# Critical Review of all RPR MAC Proposals

Harmen R. van As, Arben Lila, Guenter Remsak, Jon Schuringa  
Vienna University of Technology, Austria

The comparison is put together as a basis for discussion in the MAC fairness subgroup during the St. Louis meeting, March 11-14, 2002

# Gandalf / Darwin

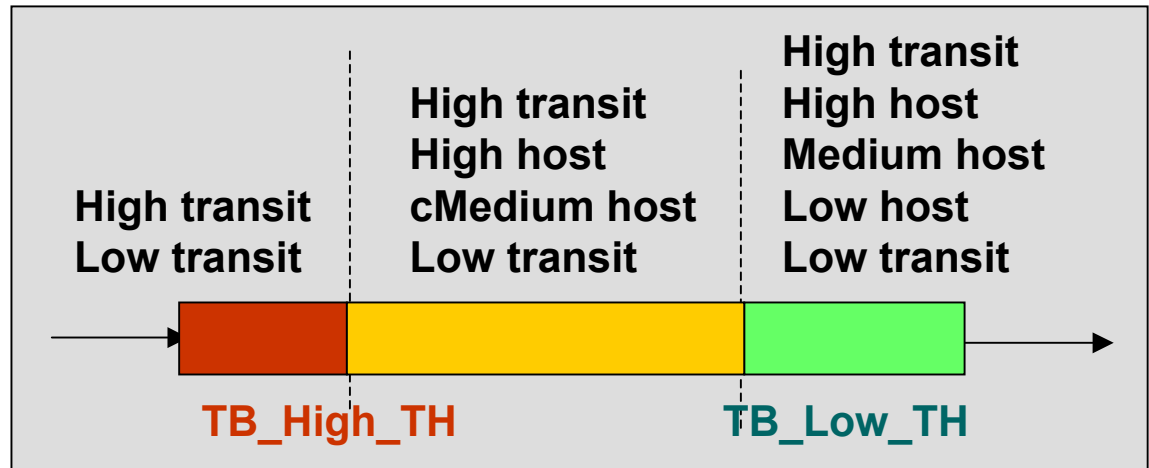
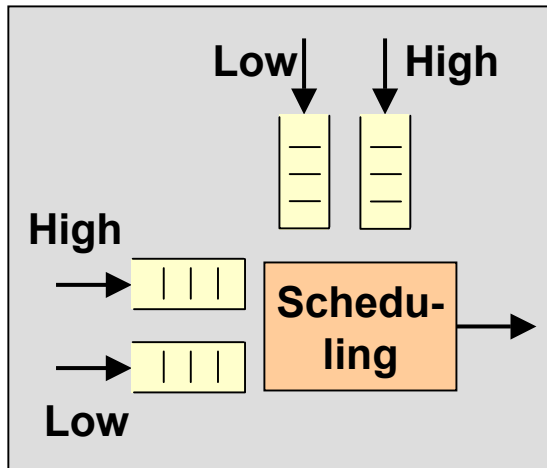
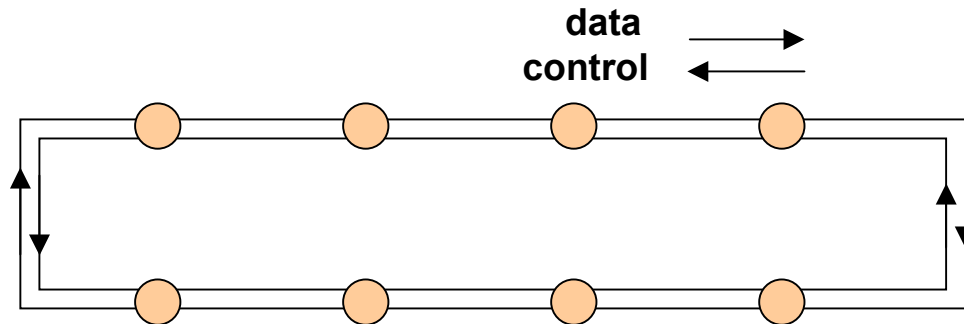
**Gandalf:** - many parameters and constants

**Darwin** - threshold procedure is rather complex

- Gandalf:** - many parameters to be set,  
**Darwin** - only heuristic knowledge about parameter setting  
- strong relationship between parameters and traffic pattern
- DVJ:** -?
- Alladin:** - few parameters
- IKN:** -few parameters, easy to make them adaptive

- Gandalf:** - difficult (many parameters, stochastic behavior, etc.)
- Darwin** - how to test proper setting of parameters in all stations?  
- how to test behavior
- DVJ:** - ?
- Alladin:** - ?
- IKN:** - easy (deterministic scheduling, no local properties)

# Alladin

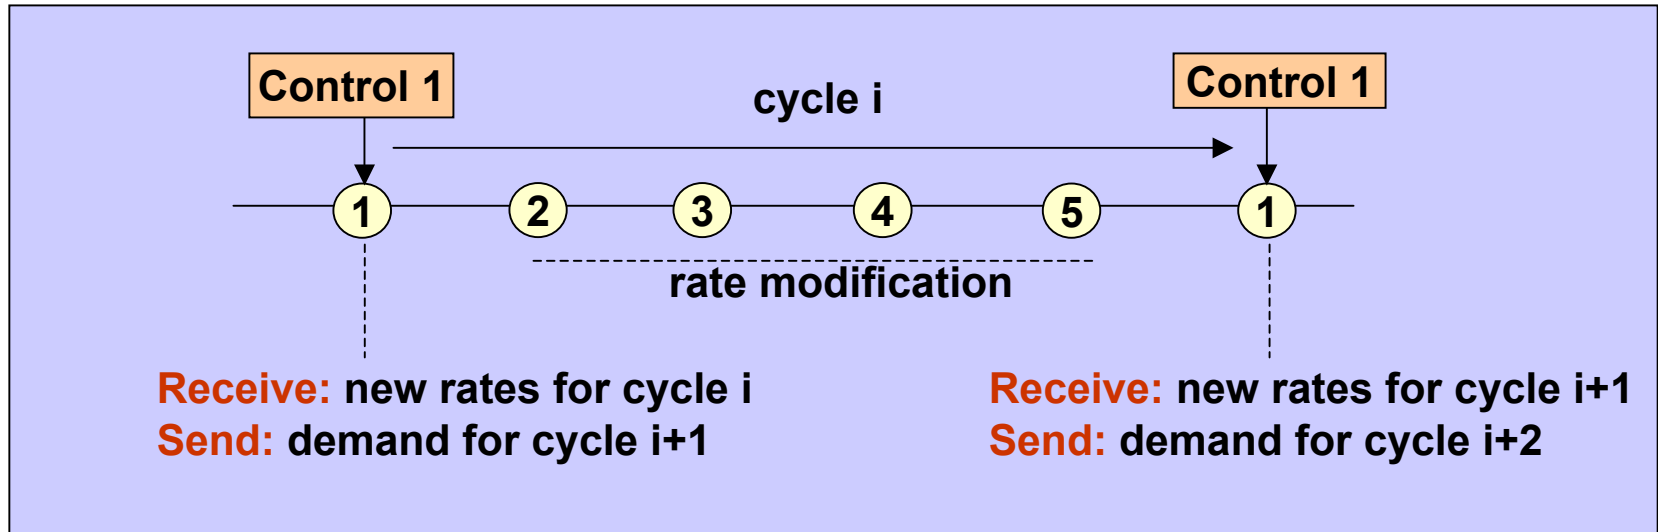
**Alladin:** - cyclic bottleneck fairness advertisement  
- local fairness scheduling

# DVJ

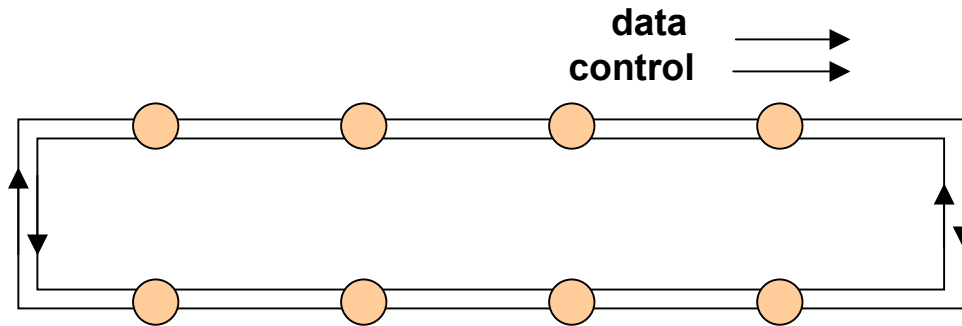
**DVJ:** ?

# IKN

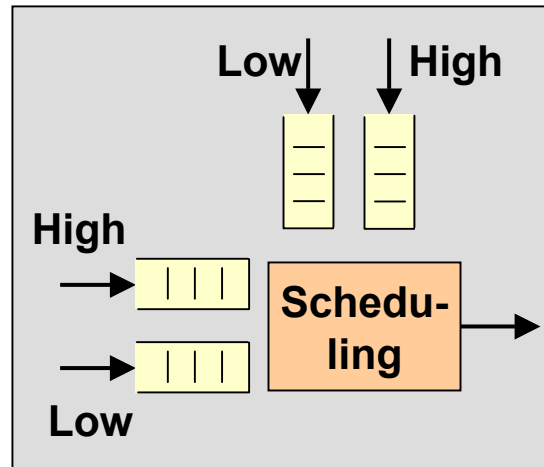
**IKN:** - cyclic demand advertisement  
- single control packet  
- local bottleneck fairness scheduling
